## **ADDENDUM NO. 1**

**PROJECT:** SAGINAW COUNTY PARKING LOT AT:  
400 BLOCK JOHNSON STREET

**DATE:** 7/26/2012

**3 DETAIL**  
C5.3 3/4" = 1'-0"

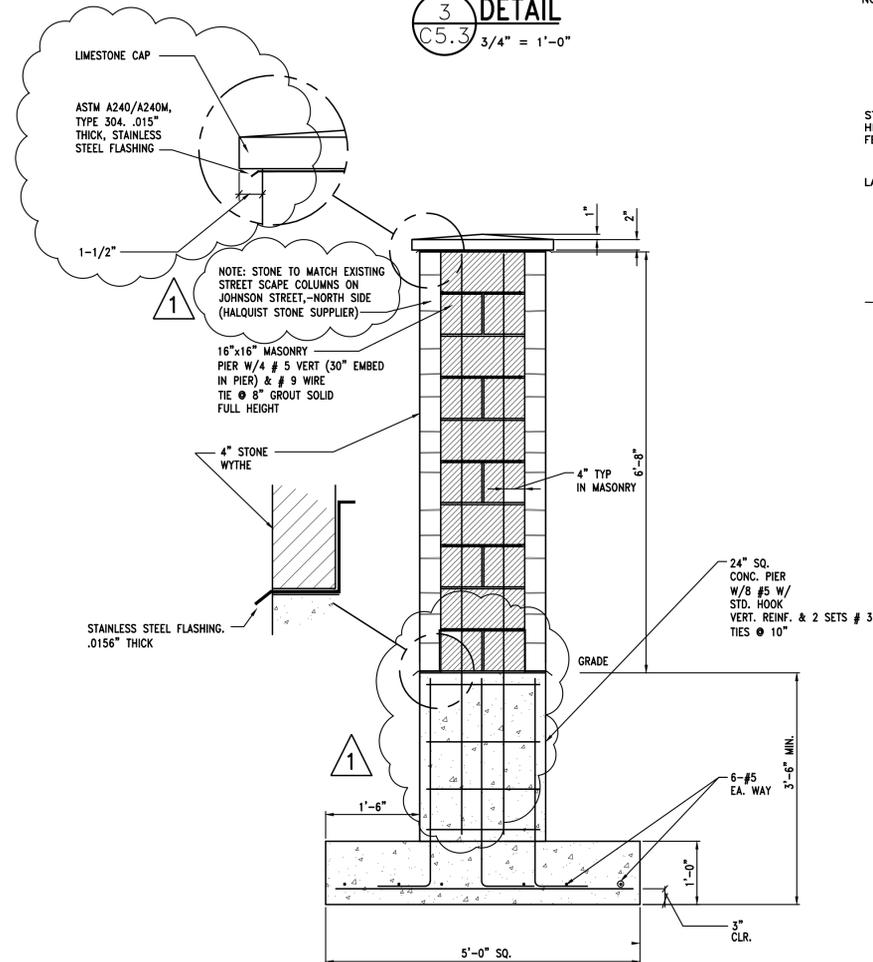
5. Refer to sheet C4.1, match existing top of curb grades for new street curb at existing entrance along Jefferson.
6. Refer to sheet C5.3  
Detail 3/C5.3 - revised re-bar designations  
Detail 4/C5.3 -Limestone cap and stone cladding information, extend rebar from footing into wall.
